MODEL 80, 80-F
83, 83-F

ATWATER KENT MFG. CO.

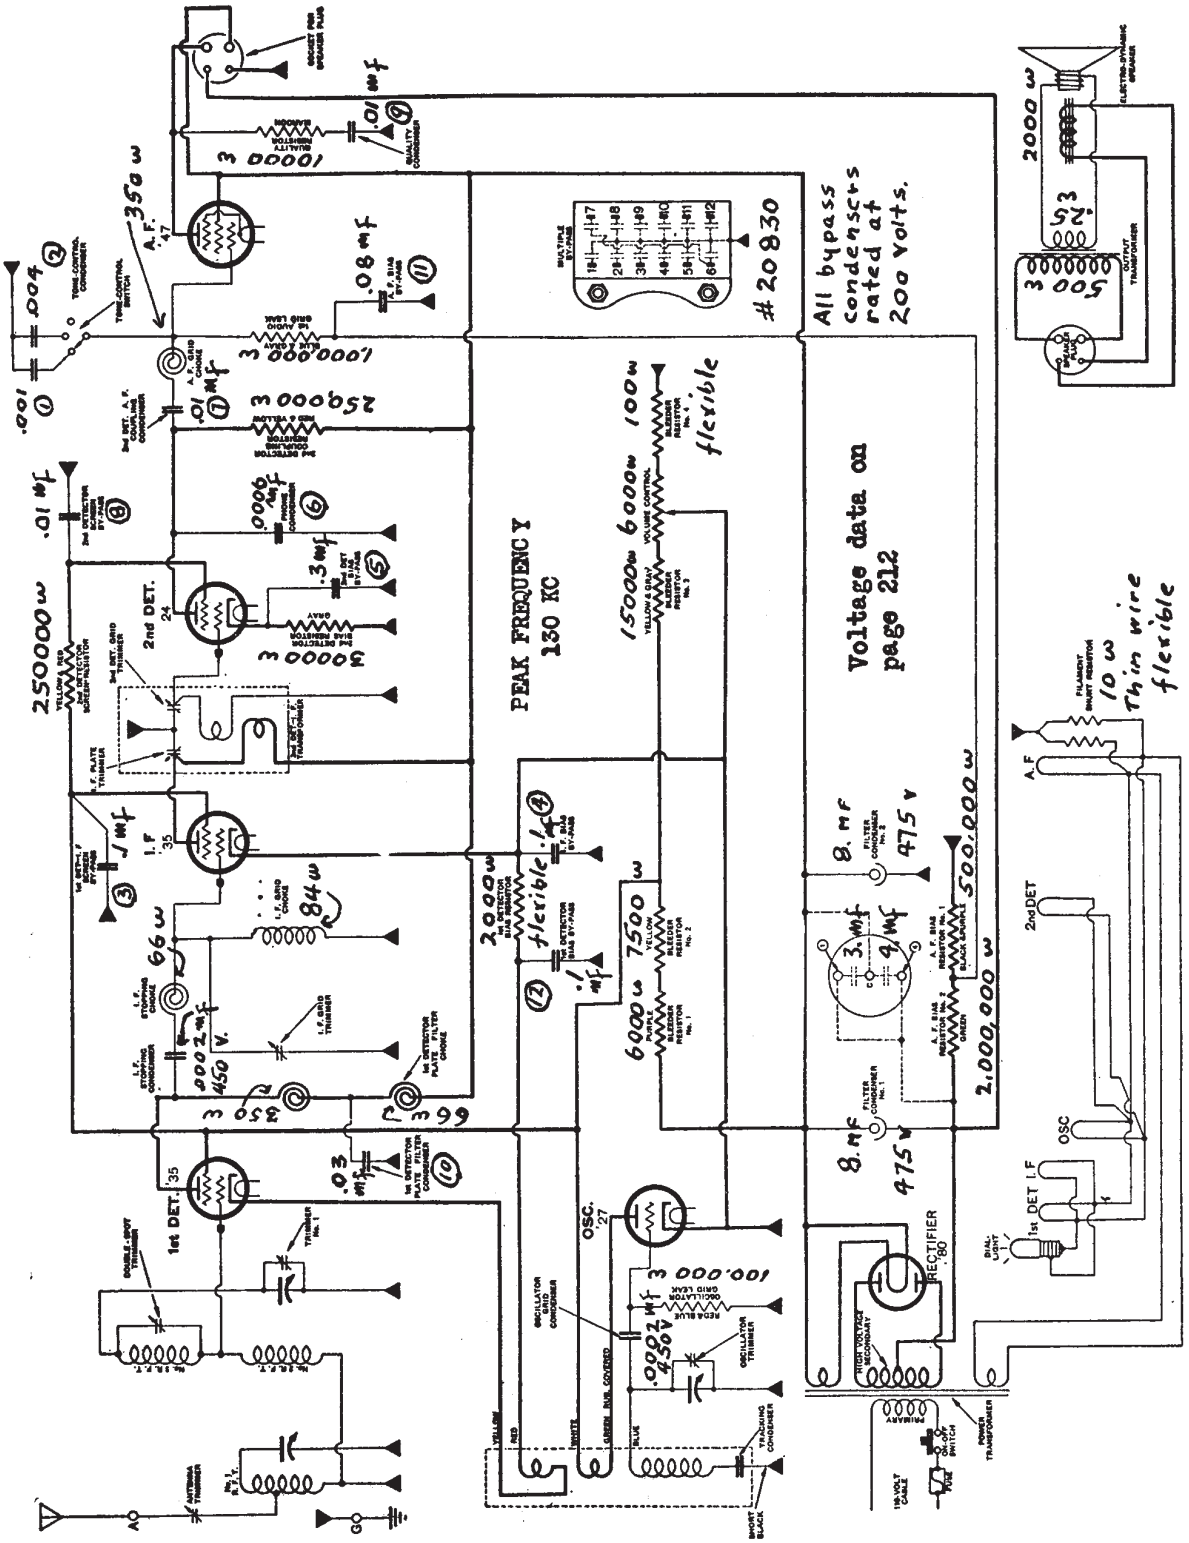
In Model 83 and 83-F, a filter-condenser unit is used and it is connected as shown in dotted lines. This unit is NOT used in Model 80 and 80-F. In Model 83, 83-F, the electrolytic filter condenser No. 1 is not used, and the filament circuit is slightly different.
